October 9, 1984

Docket No. 50-271

The Commission has issued the enclosed Amendment No. 83 to Facility Operating License No. DPR-28 for the Vermont Yankee Nuclear Power Station. The amendment consists of changes to the Technical Specifications in response to your January 23, 1984 application.

The amendment authorizes changes to the Technical Specifications (1) to implement the requirements of Appendix I of 10 CFR Part 50, (2) to establish new limiting conditions for operation for the quarterly and annual average release rates, and (3) to revise environmental monitoring programs to assure conformance with the Commission's regulations.

Figure 1. Liquid Radwaste Treatment Systems, Effluent Paths, and Controls for Vermont Yankee Nuclear Power Station

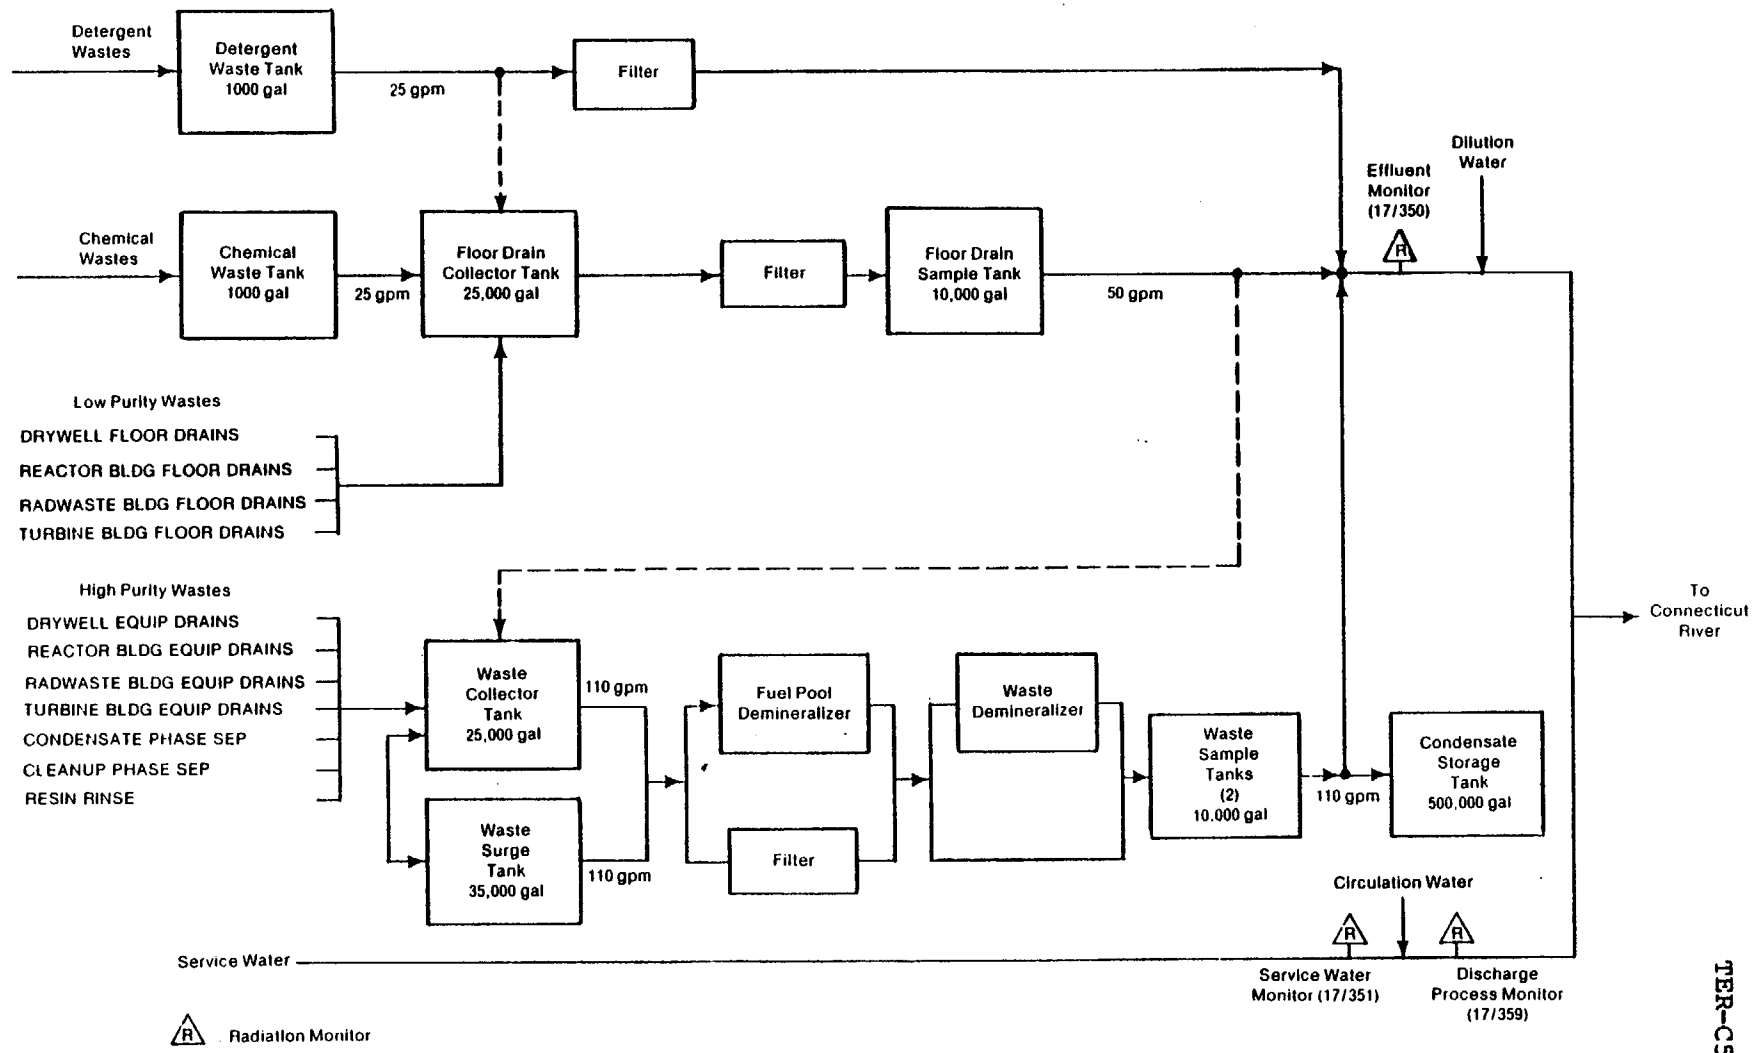
A radiation monitor (No. 17/350) has been installed for the liquid radwaste effluent line (Figure 1) which combines effluent streams from the releases of high purity wastes, low purity wastes, chemical wastes, and detergent wastes. The Licensee has also provided a monitor (No. 17/351) for the main service water, which combines with the circulation water at the discharge structure, where a process monitor (No. 17/359) is also provided.
